Service Bulletin

SAFETY RECALL

2002-2005 VFR800/A Wire Harness Replacement

WIRING HARNESS & ROUTING INFORMATION

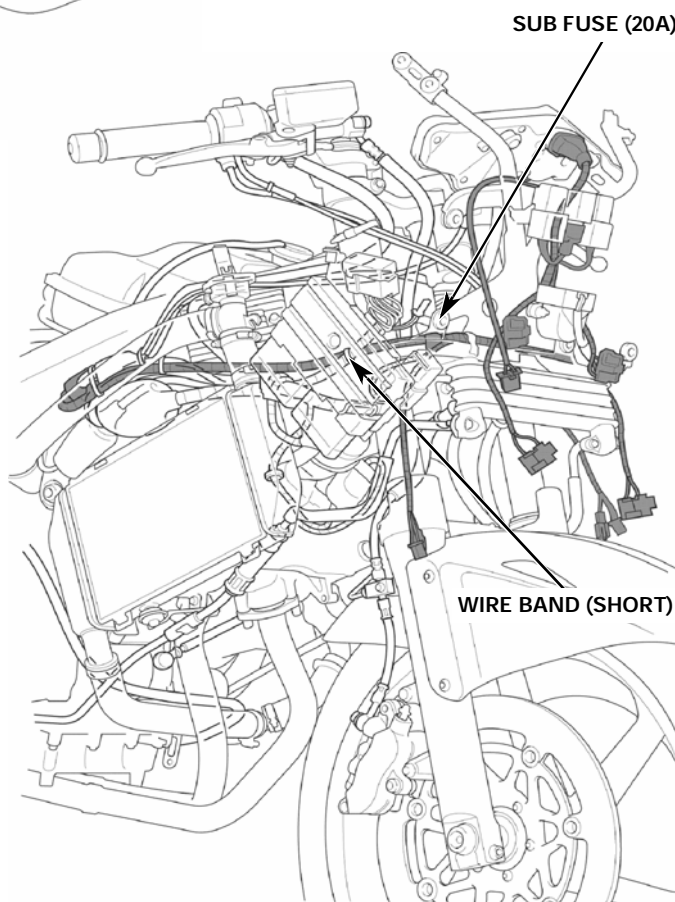
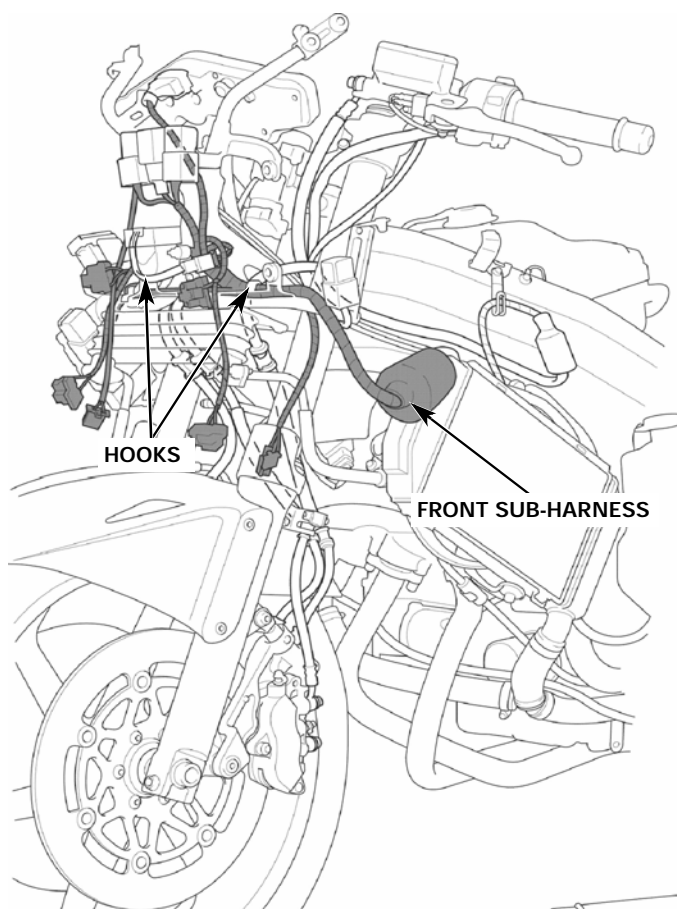
NOTE: For routing specifications, refer to the WIRING & HARNESS ROUTING SECTION on pages 7-8.

2002-2003 VFR800A (ABS TYPE)

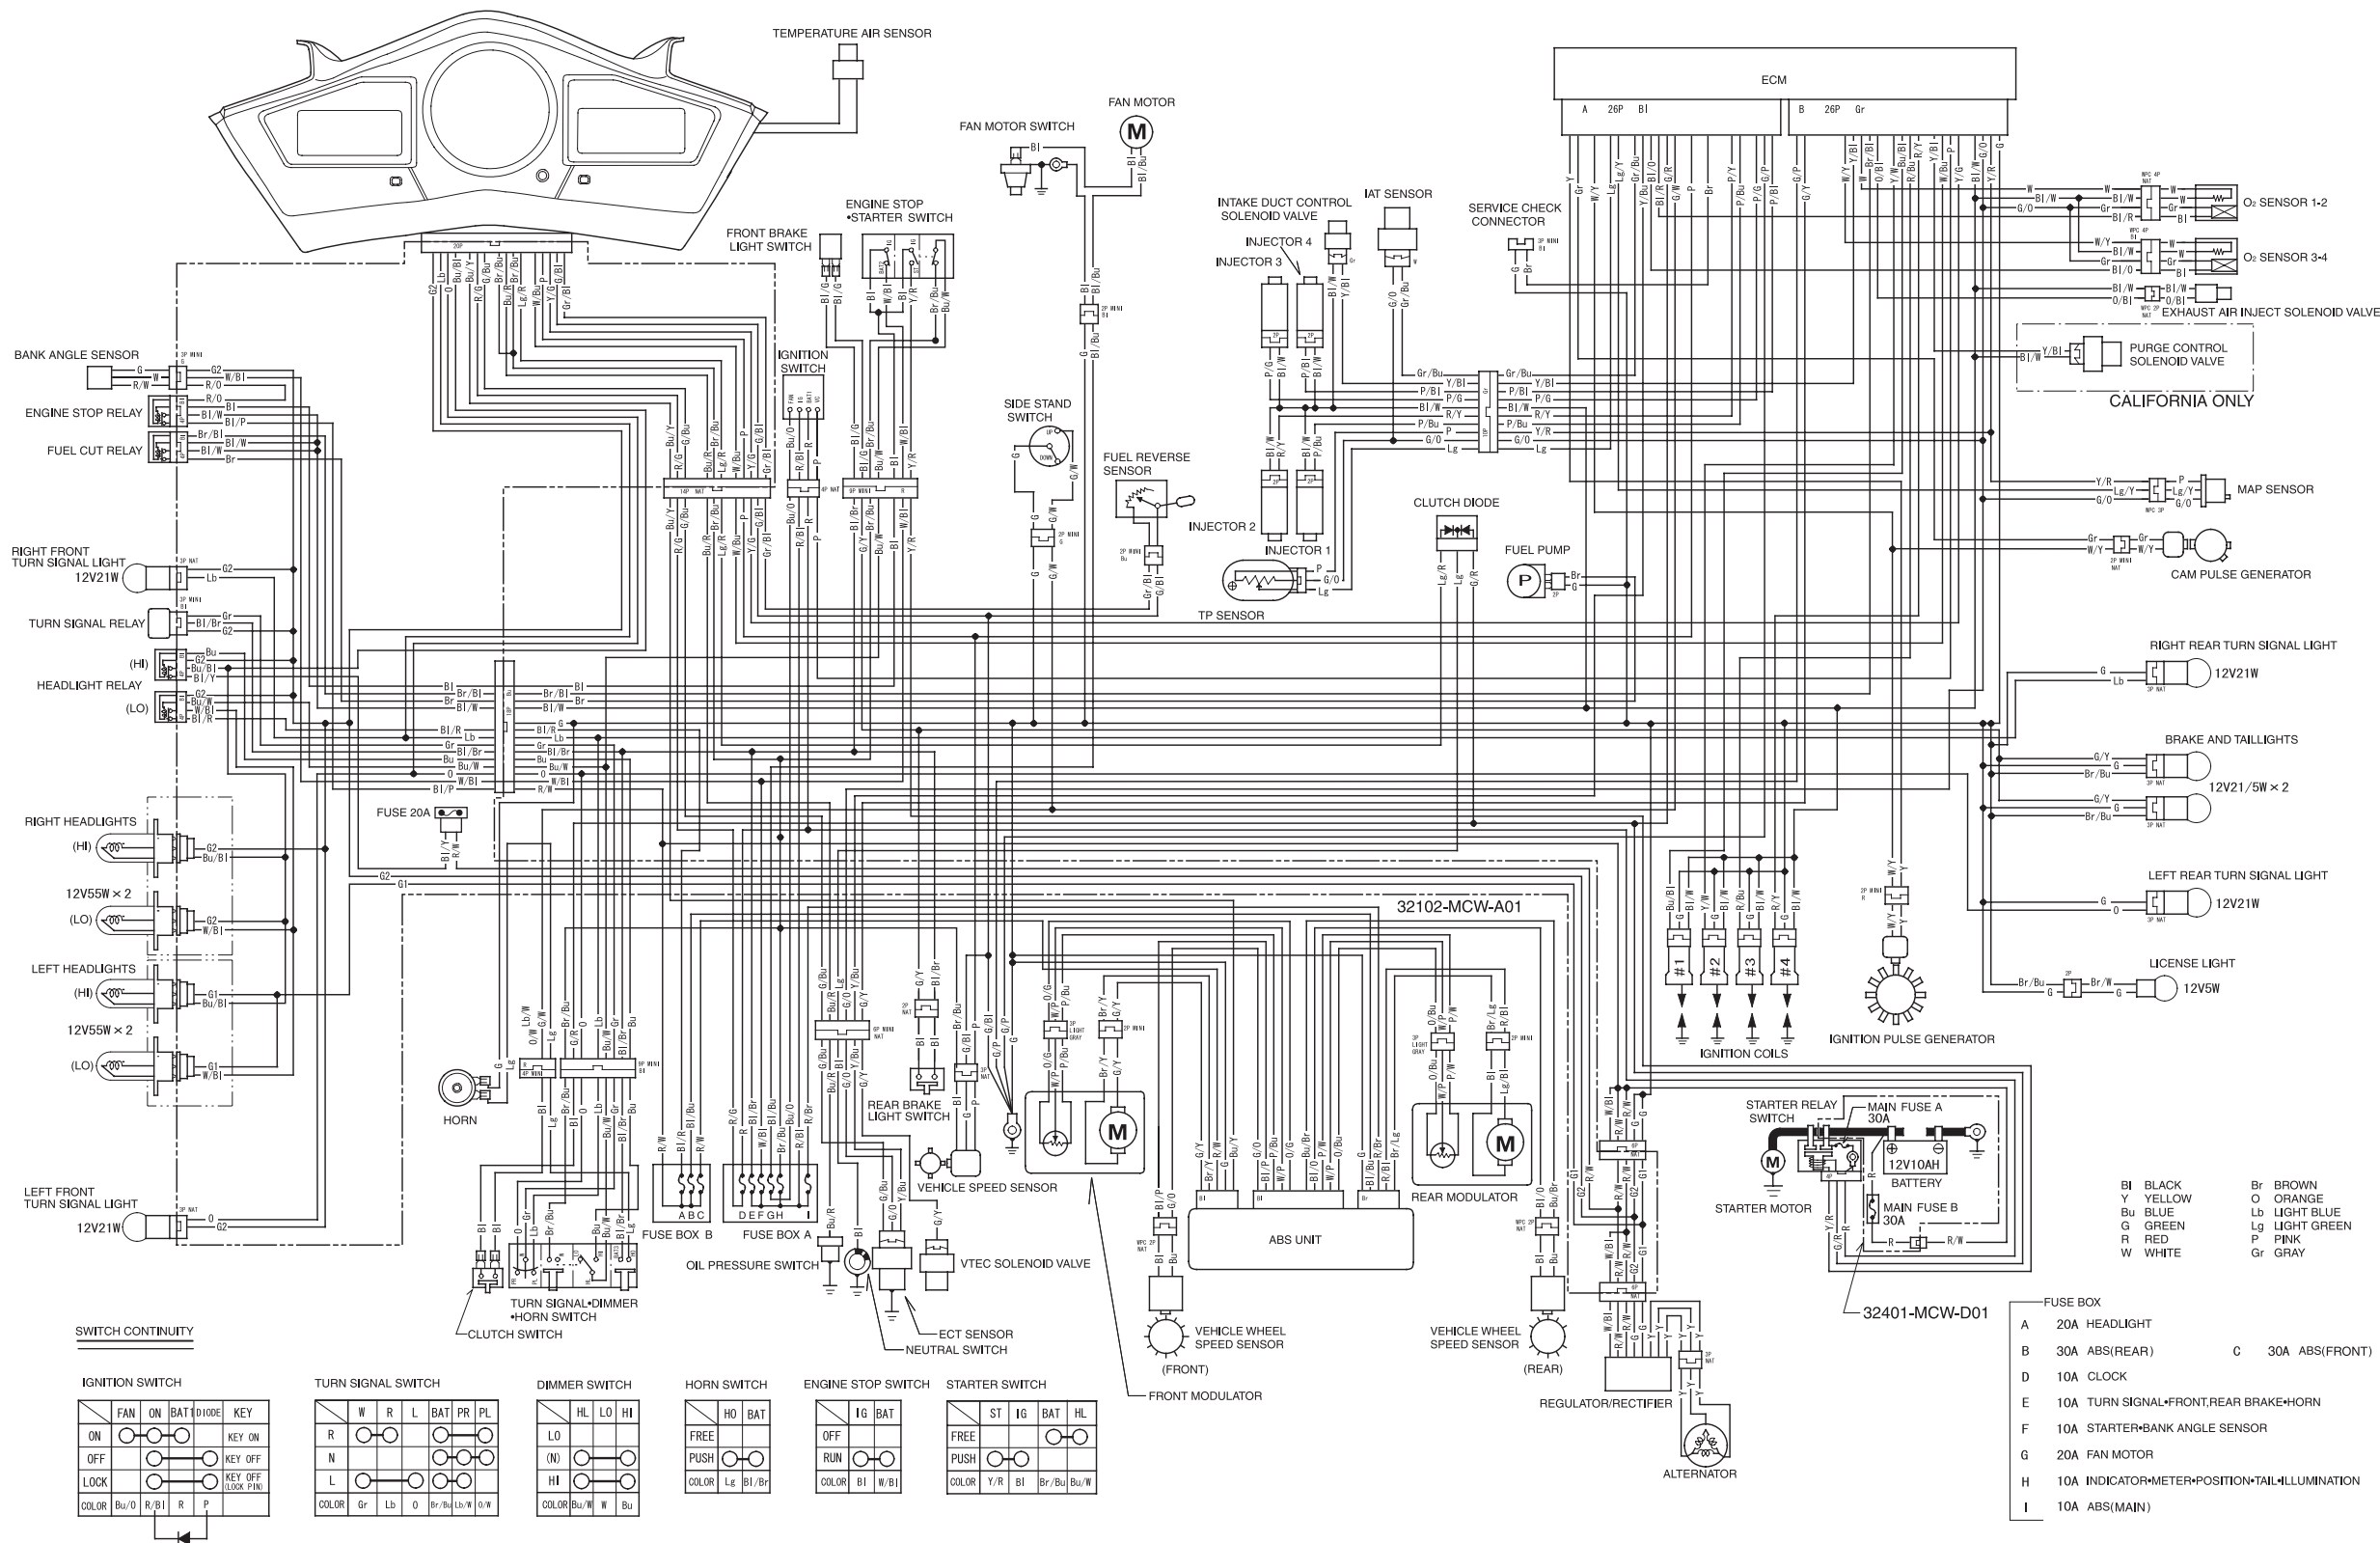
NOTE: Updated illustrations of the wiring diagram for the affected models are included with this Service Bulletin.

MODIFIED WIRING DIAGRAM
